Second Submission Review

SUMMARY OF KEY COMMENTS FROM ALL DEPARTMENTS

7-ELEVEN AT SMITH & TOWER

SITE DEVELOPMENT PLAN

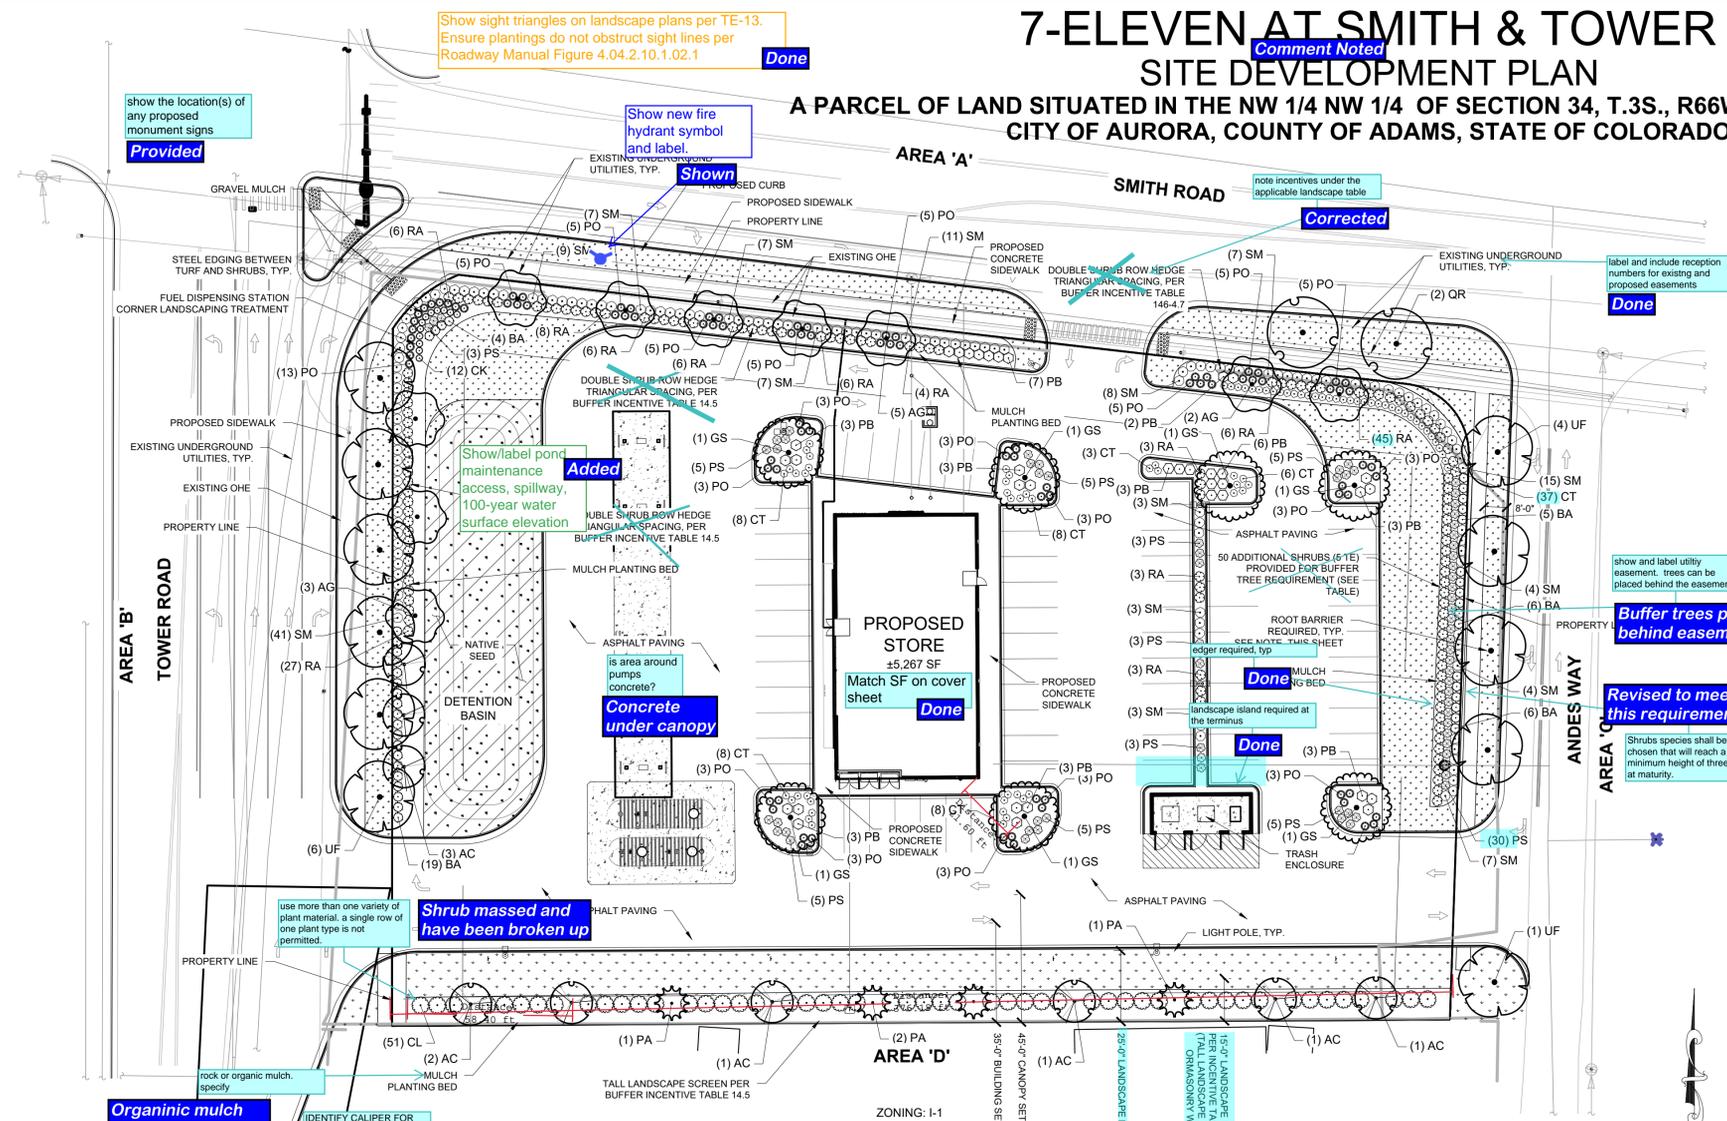
where is the loading area?
Loading area is south drive aisle which is currently shown at 40' width to have adequate room for vehicle passing.

ARCHITECTURAL BUILDING ELEVATIONS
7-ELEVEN AT SMITH & TOWER
SITE DEVELOPMENT PLAN
LEGAL DESCRIPTION 2
7/6/2021
SHEET 6 OF 10

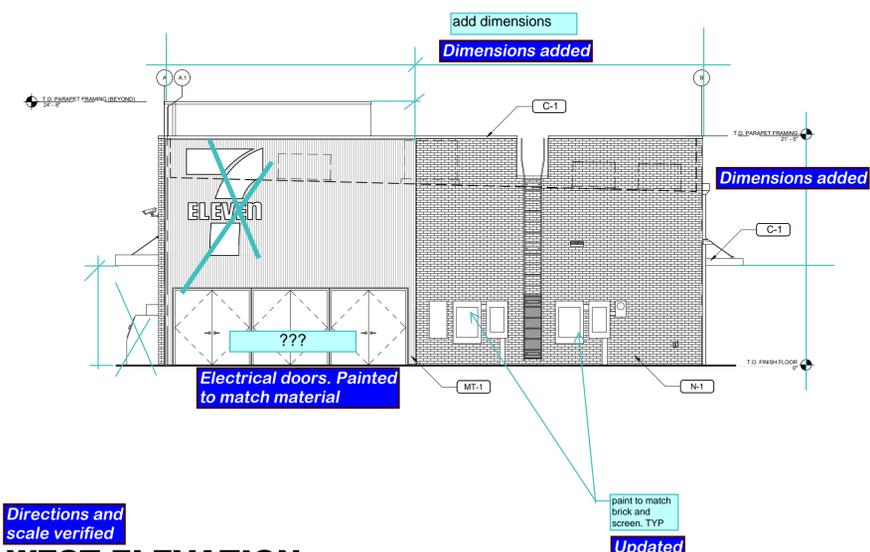
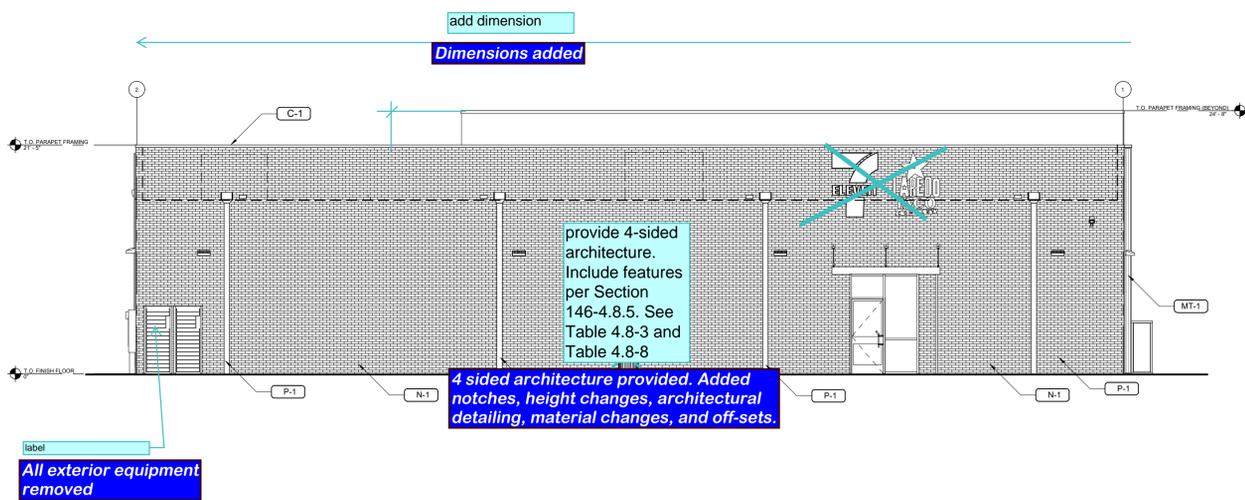
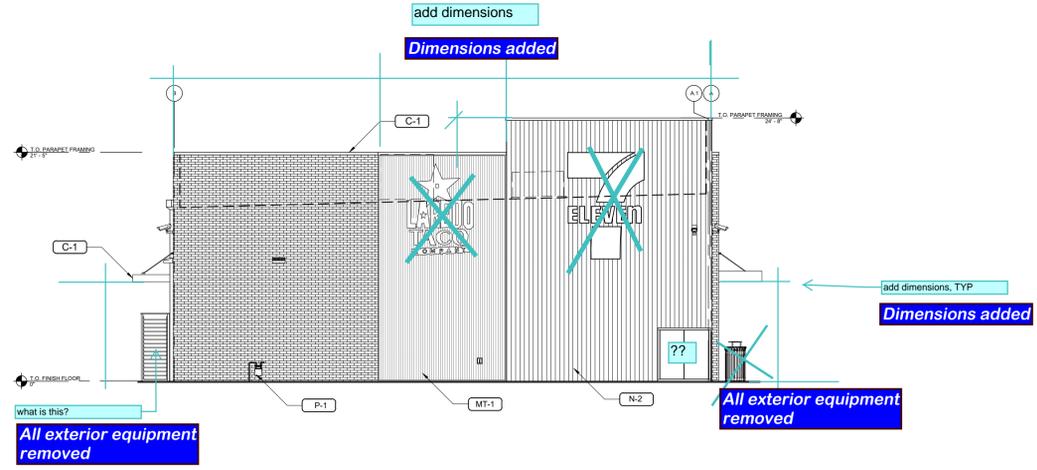
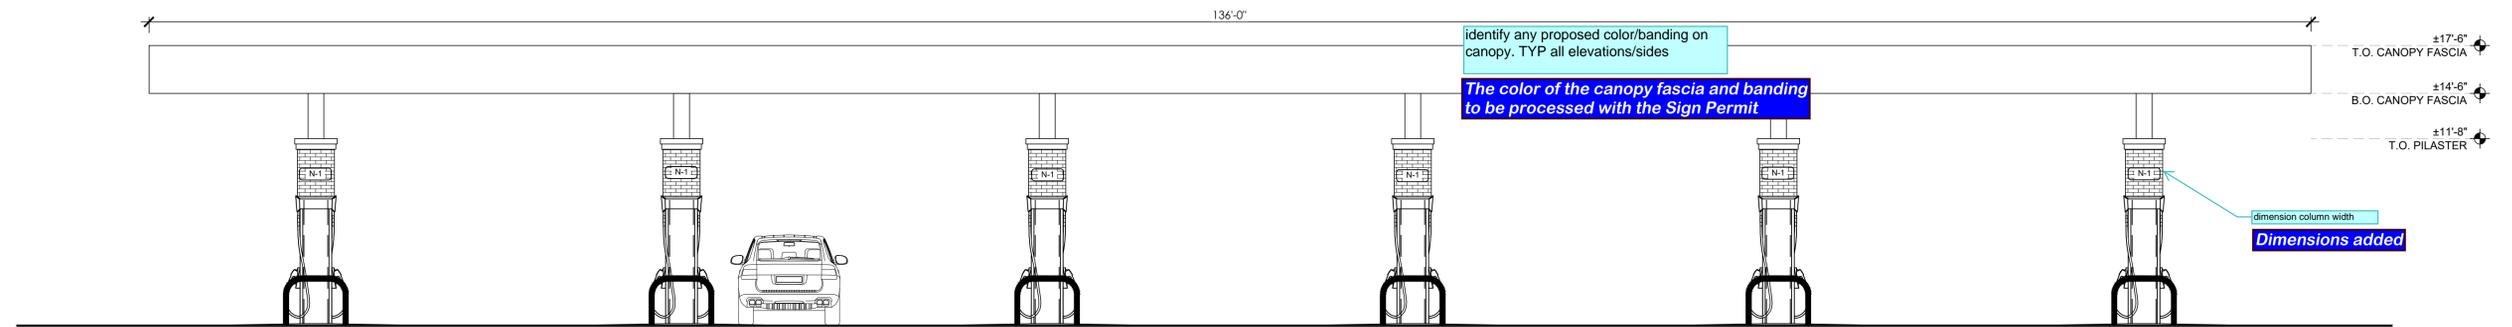
3B. Building elevations appear to be labeled incorrectly. Please revise.

3D. Four-sided architecture is required. Add variations in the building façades and/or materials to enhance all building elevations. See Table 4.8-8 for the architectural requirements for primary, secondary and minor facades and ensure that each façade meets the requirements. The rear façade specifically needs enhancement.

3G. Remove all signage from the elevations. You may show a light, dashed line and indicate that is the location of future signage.

only show what is used
Updated

Revised accordingly.

Four-sided architecture provided. Added notches, height changes, architectural detailing, material changes, and off-sets.

Revised accordingly.

1 NORTH CANOPY ELEVATION

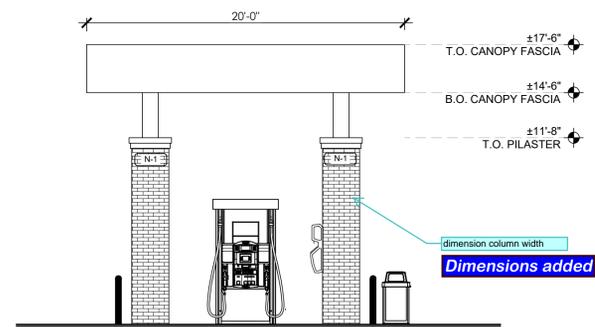
3C. Show the outline of the fuel canopy and dimension. Show any proposed color banding on the canopies. Show for all 4 sides. Accent colors may be used as decorative elements on the canopy fascia, but they shall be limited to horizontal bands of a total area not to exceed 40 percent of the area of the canopy fascia.

Directions and scale verified

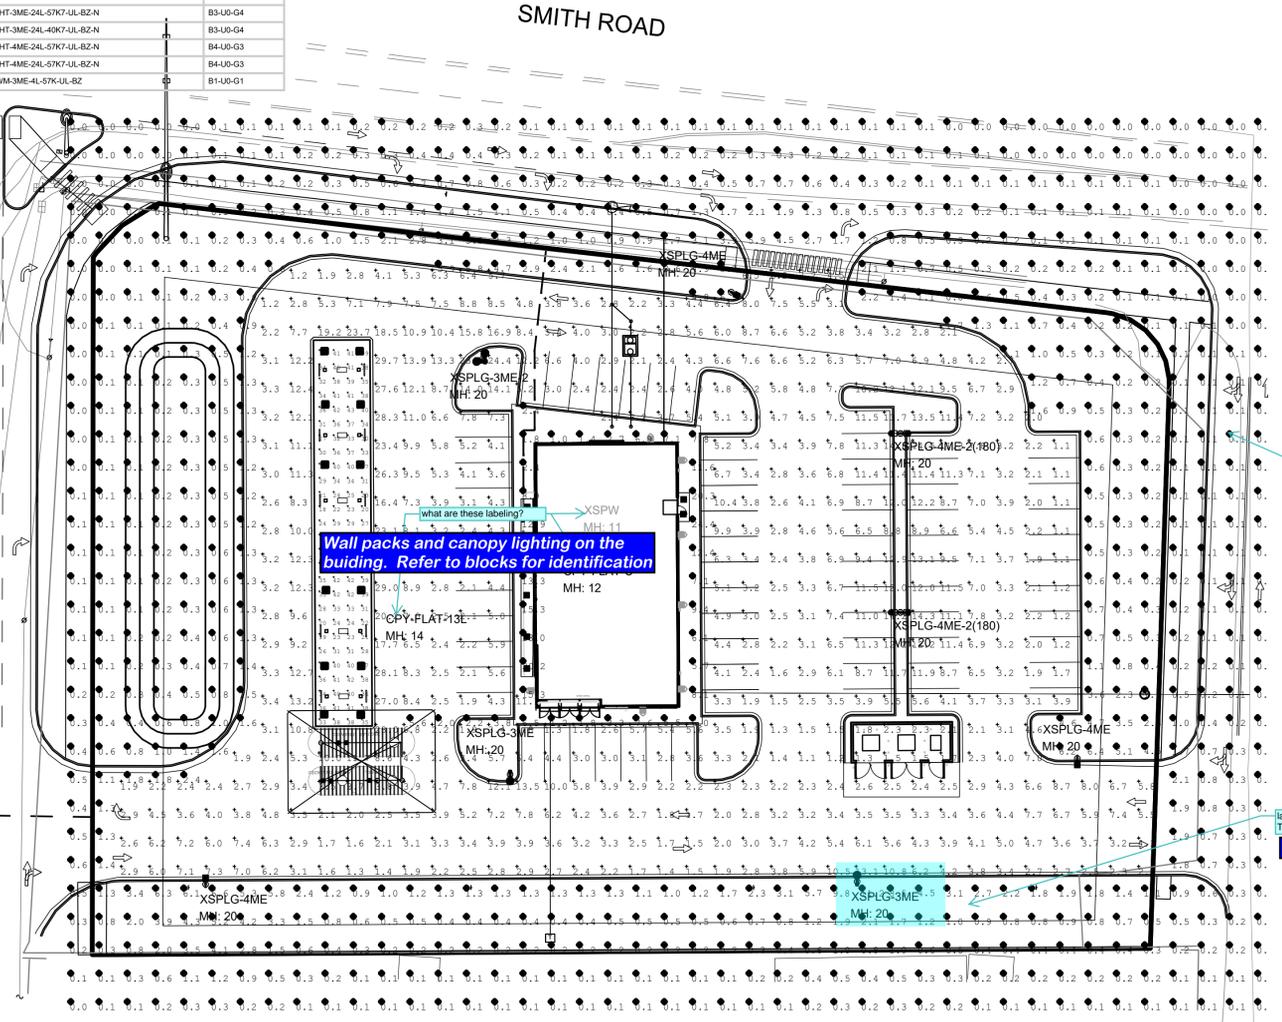
A COMPANY OF IDEAL INDUSTRIES, INC. 8201 Washington Ave, Racine, WI 53406 (920) 236-6600	Project Name: 7-Eleven #1045416 Aurora, CO - Smith & Tower SR-35521	Footcandles calculated at grade Filename: 711-210503ARCOLJSR1.AGI	Layout By: LINDA SCHALLER Date: 6/29/2021
	remove the titleblock Completed

2
4 WEST ELEVATION
SCALE 1/8" = 1'-0"

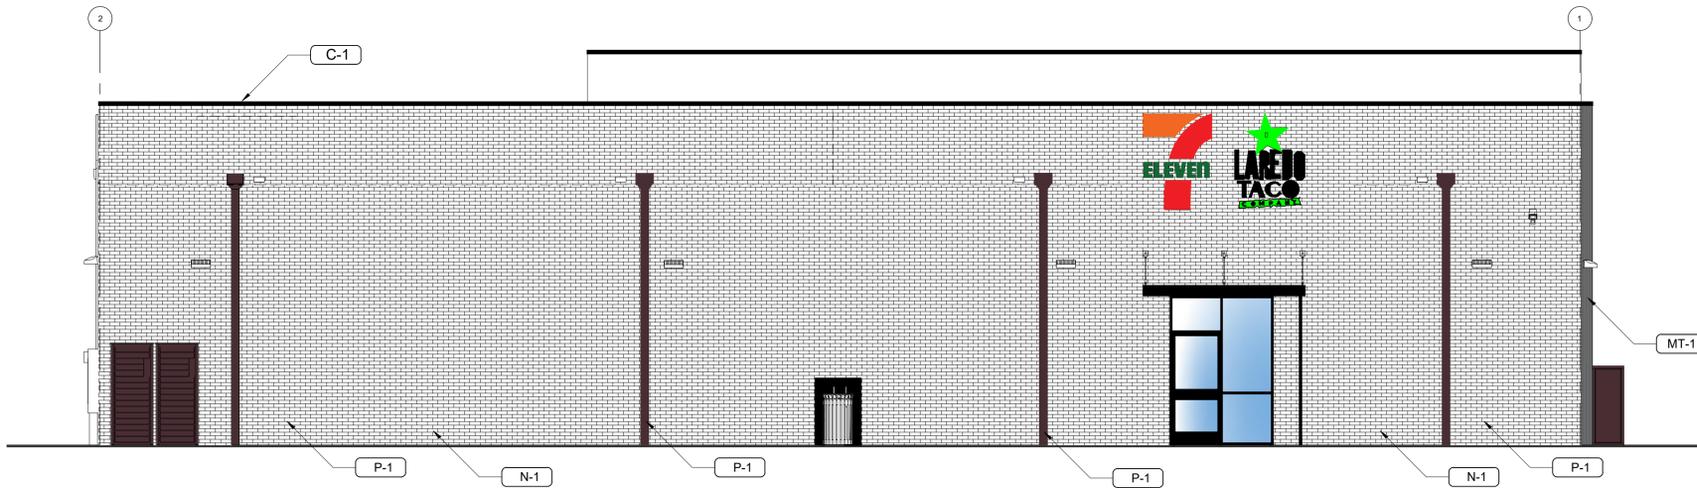
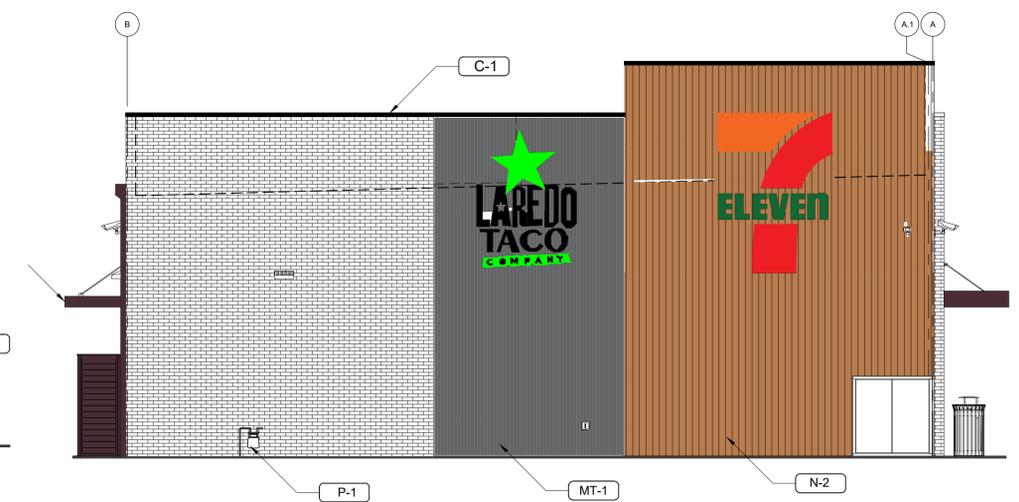
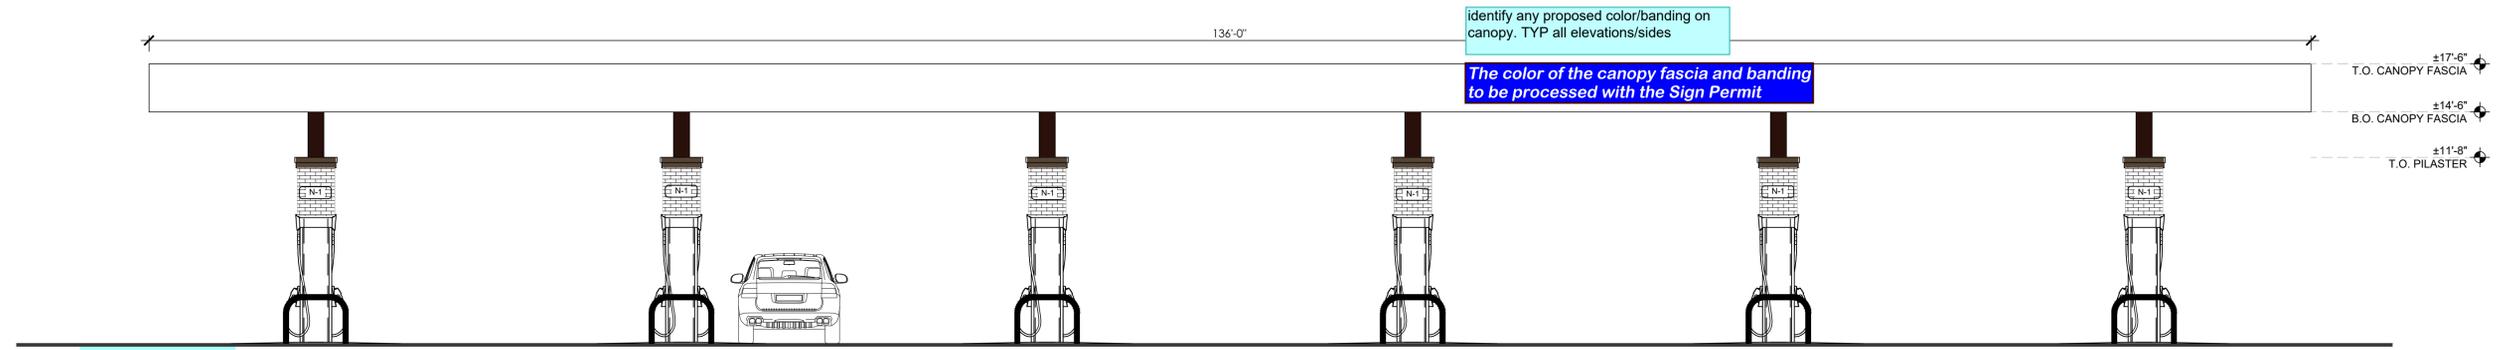
verify directions of elevations. TYP

Directions and scale verified
